Changes made in EX200 INFRA Cabin

1. Changes in Floorplate
2. Changes in Cabin assembly

TC21199 – Floor Plate

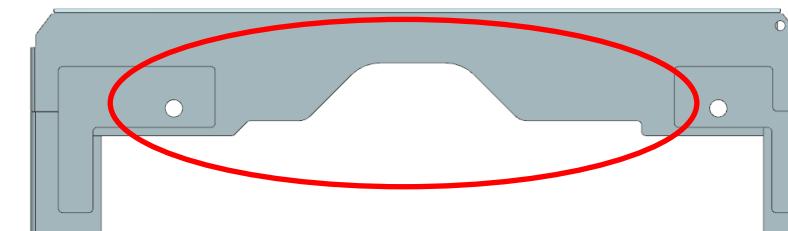
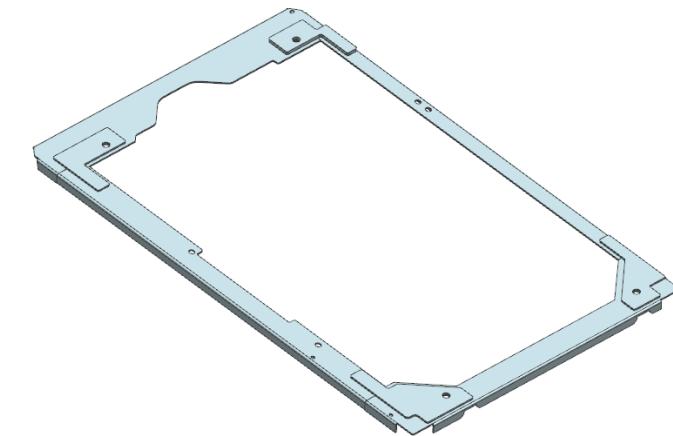
Cut out added in floorplate due to travel lever fouling with floorplate during assembly

TC21199 – Floor Plate

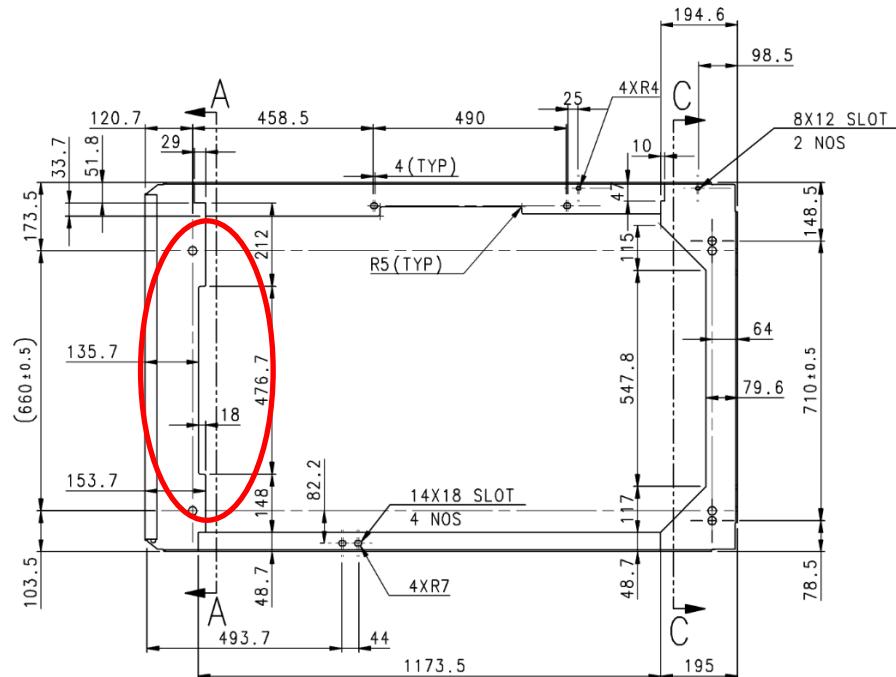
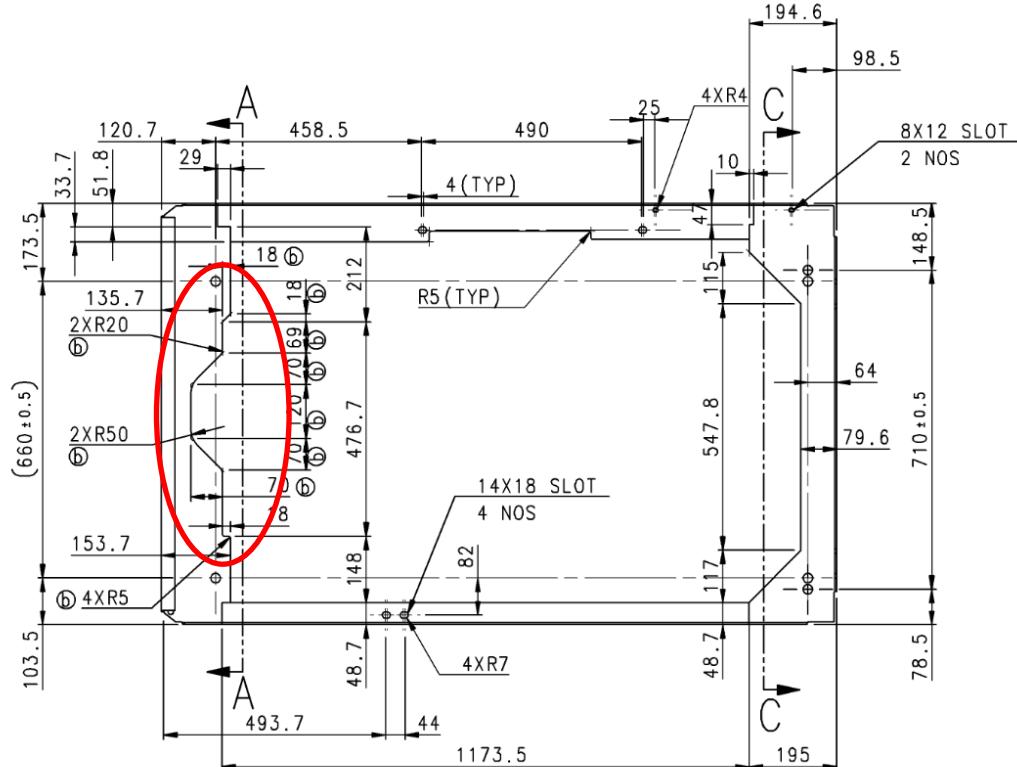
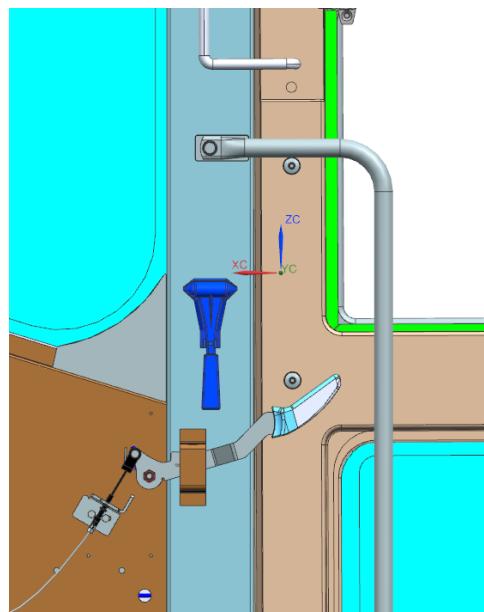
Cut out added in floorplate due to travel lever fouling with floorplate during assembly

TA12476 – Cabin

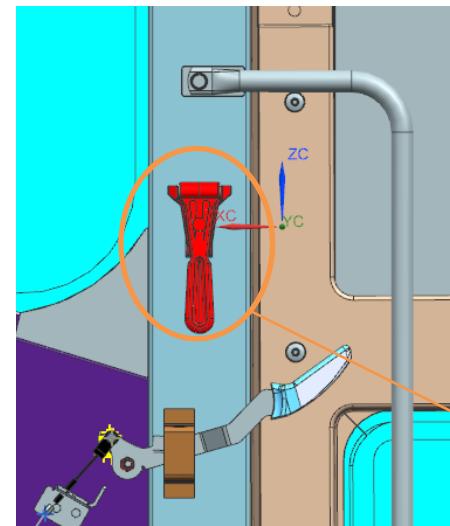
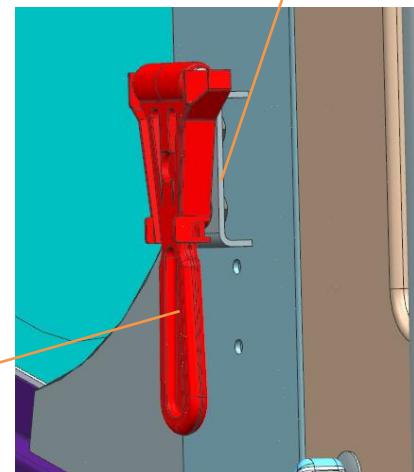
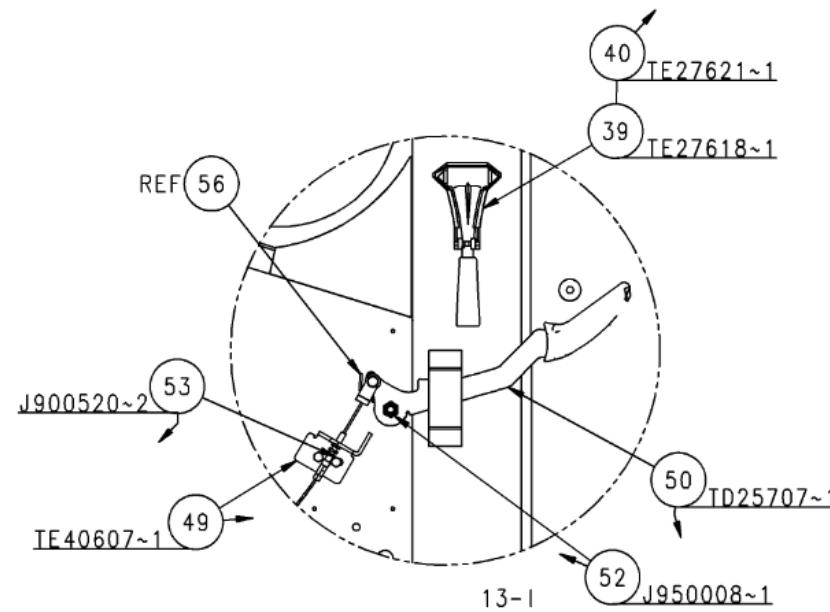
Emergency glass breaking hammer is changed to 'Pacoline hammer' as a cost reduction idea

TA12476 – Cabin

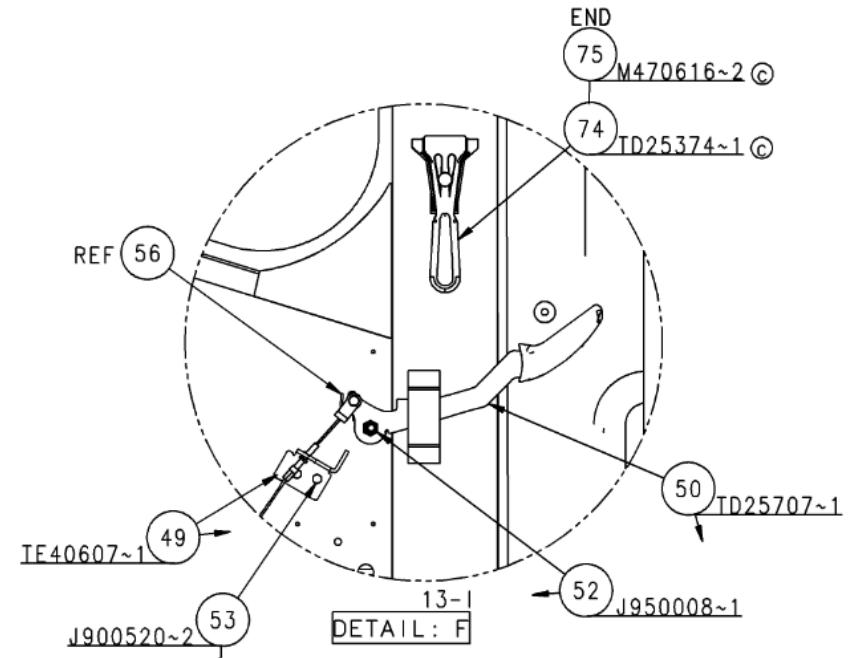
Emergency glass breaking hammer is changed to 'Pacoline hammer' as a cost reduction idea

FLOOR PLATE ASSY
 Sheet No. 1 of 1 Sheets

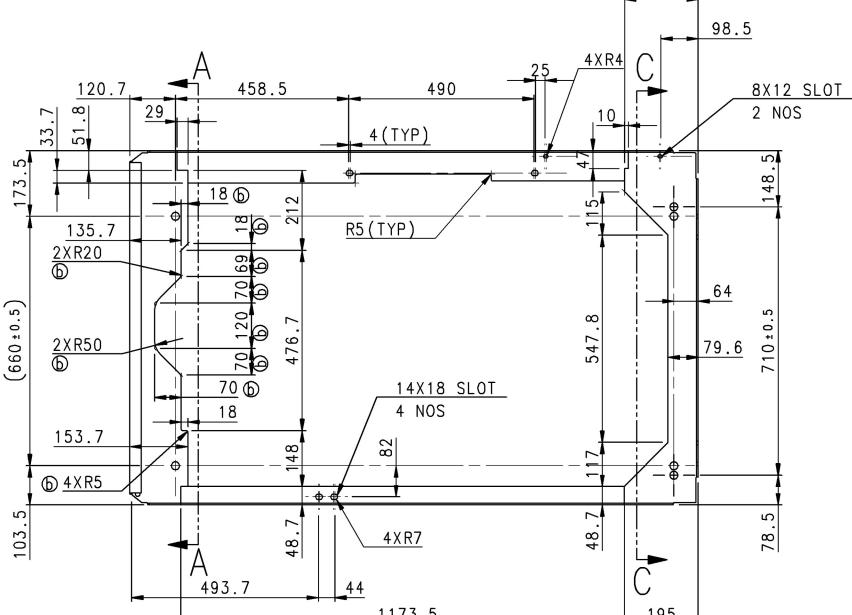
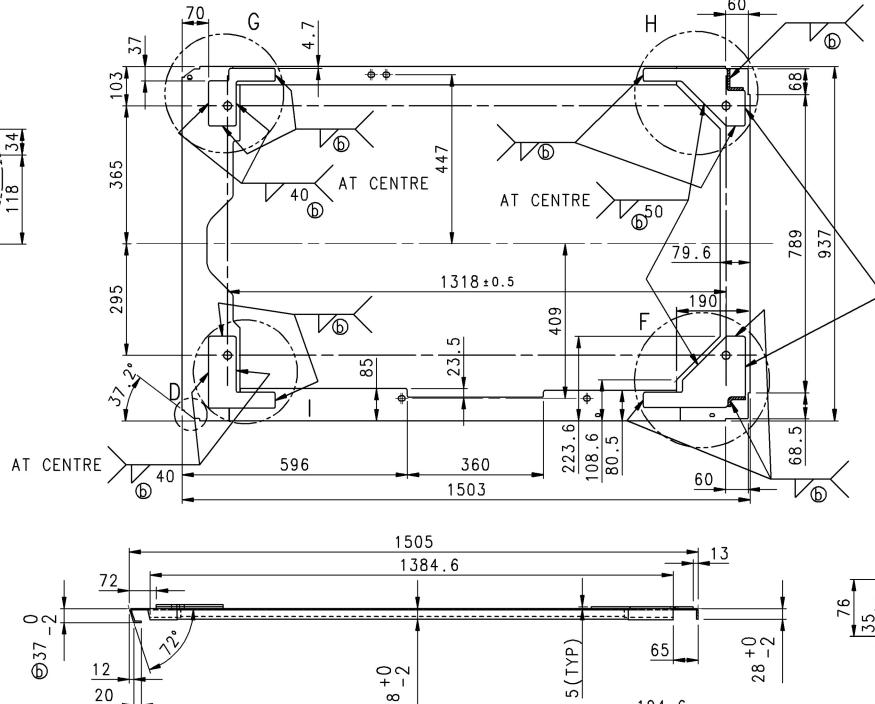
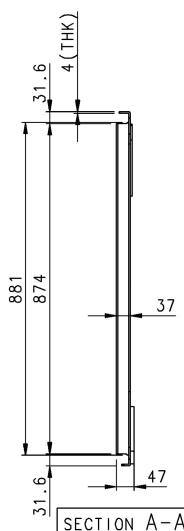
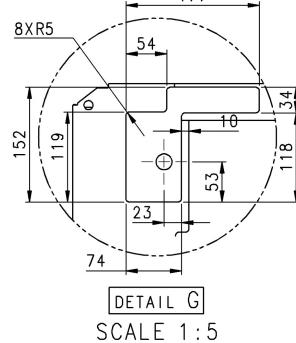
IT-1,2,6 MODIFIED, DIM 37 WAS 28, DIMS 18,69,70,120,R5,R20,

R50 ADDED, WELDING MODIFIED FOR IT-1,2,4 & 5, ECN NO S200-2351.
